TECHNICAL NOTE

Job Name: Great Haddon
Job No: 15188-503
Note No: ESP N28.1.13
Date: 28 January 2013
Prepared By: Angela Lamacraft
Subject: **Response to Queries from the Principal Development Management Officer
Peterborough City Council**

Figure 1

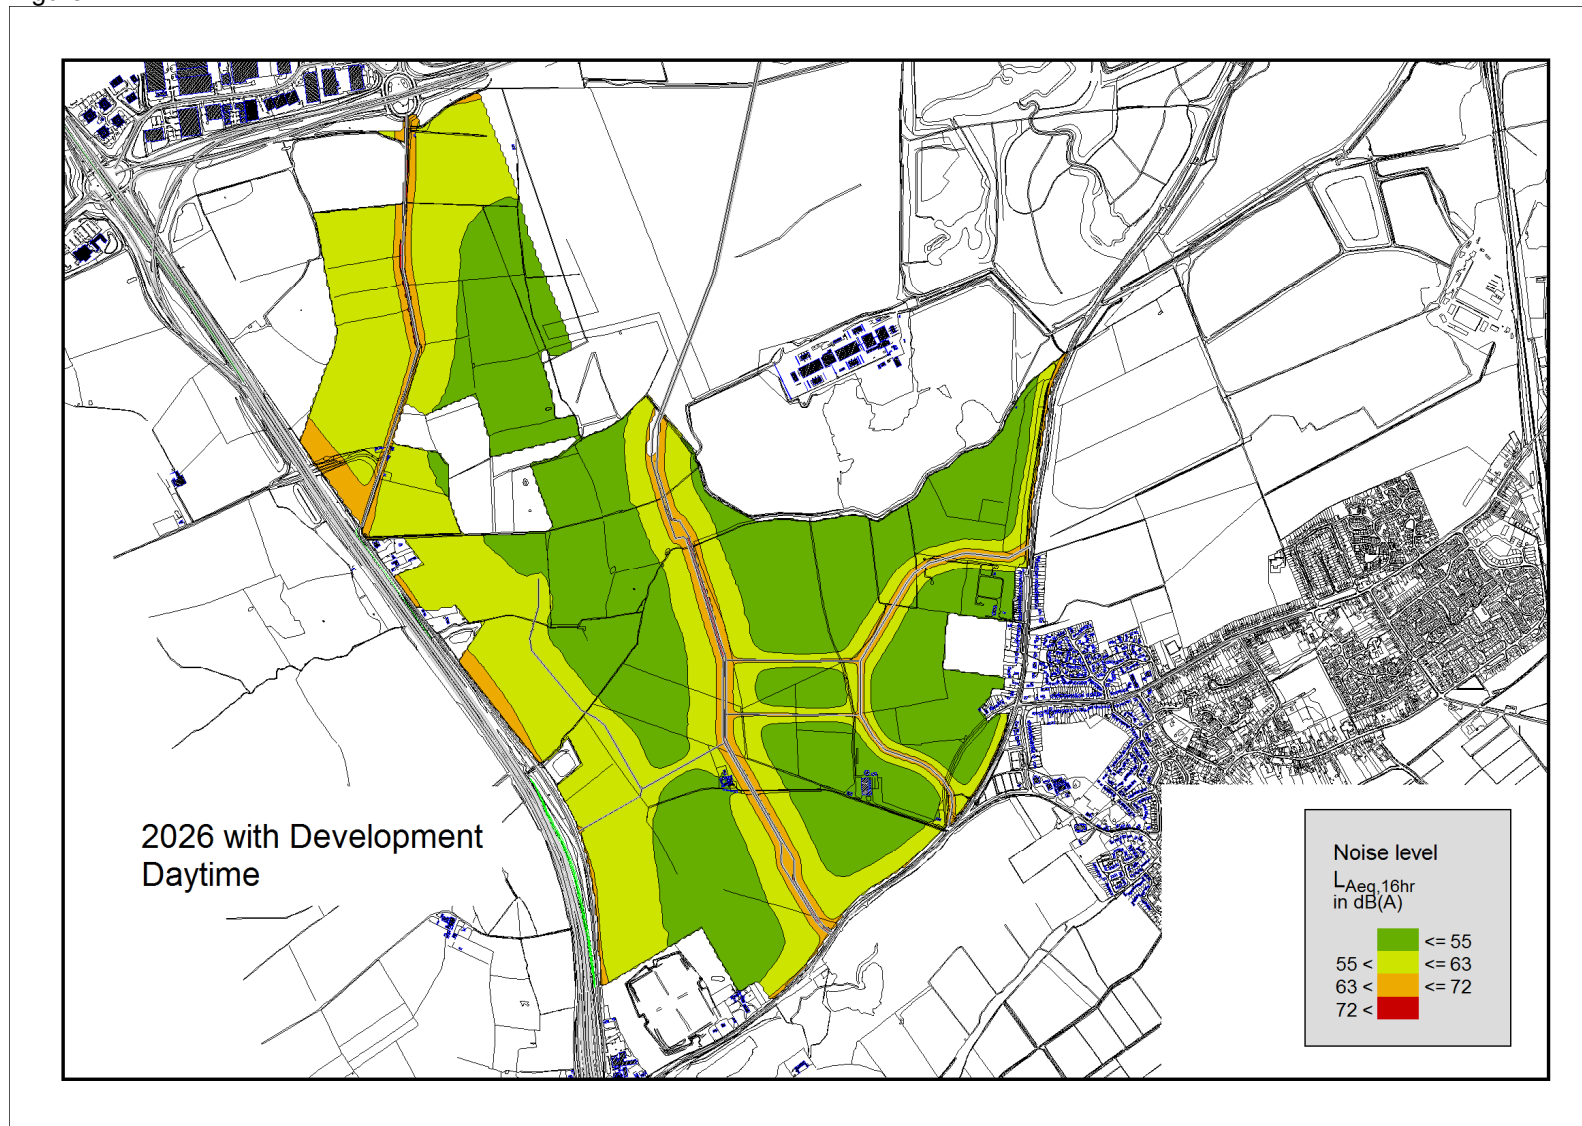
Item	Subject
1.	<p>Introduction</p> <p>In an email dated 19 July 2011 Vicky Hurrell (Principal Development Management Officer Peterborough City Council (PCC)) had the following queries regarding the noise and vibration ES Chapter for Great Haddon:</p> <ul style="list-style-type: none"> The updated ES includes the 2026 Do Something Daytime Noise Contour Plan but not one for Night time. Please can you provide/confirm why this is not relevant, Our Regulation 19 request noted that it was unclear what NEC noise categories the different areas of development fall within and asked for clarification in order to confirm that no development was proposed within NEC C or even D. This does not appear to have been done as we had intended. Please can you amend the key to the drawings in respect of 2026 Do Something Daytime and Night time Contour Plans so that the NECs are clearly shown and provide the drawings, We will need to review what impact if any the additional traffic along it would have upon the amenity of the neighbouring residents. This is as we did for the employment area to address a number of the objections received and will be an issue we will have to cover in our Committee report in due course. <p>This Technical Note address these queries.</p>

2.	<p>Night-Time Noise Contours</p> <p>The omission of night-time noise contour plans was an oversight; figures 1 and 2 provide the daytime and night-time contours for baseline and 2026 with development as Planning Policy Guidance 24 'Planning and Noise' (PPG 24) Noise Exposure Categories (NECs) – see section 3 below.</p>

Item	Subject
3.	<p>Contours as NECs</p> <p>PPG 24 implies that the NECs can only be used for 'noise levels measured on an open site at the position of the proposed dwellings' and not, therefore, for future noise levels (which are predicted, not measured). However, figures 1 and 2 provide the 2026 with development day and night-time noise levels in the NECs for clarity.</p> <p>By comparison with the David Lock Associates drawing reference pst021-dfp-01 revision H dated 11/09/2008 it can be seen that a small strip of land on the south west of the proposed residential area R9 will fall within NEC C at night. A maximum LAeq,8h of xx dB is predicted in this area, which can be mitigated with glazing with a specification of 12/16/16 (glass/cavity width/glass (mm)) is required to meet the BS 8233 criteria. Consideration of ventilation would be required, particularly on façades exposed to the noise sources (roads), to ensure that the windows could remain closed whilst maintaining adequate levels of ventilation. Acoustically attenuated ventilation, such as trickle vents, may be appropriate.</p> <p>An alternative to this would be to consider single aspect design, so that the façades exposed to the noise sources contain rooms that are not noise sensitive (bathrooms, kitchens and stairs) and noise-sensitive rooms (bedrooms and living rooms) are located so that they do not directly face the road.</p> <p>There are no proposed residential areas in NEC D.</p>

4.	<p>Great North Road</p> <p>Figures 1 and 2 include the traffic flows for Great North Road. The inclusion of these flows do not significantly increase the noise levels in this area due to the high noise level due to traffic on the A1(M).</p>
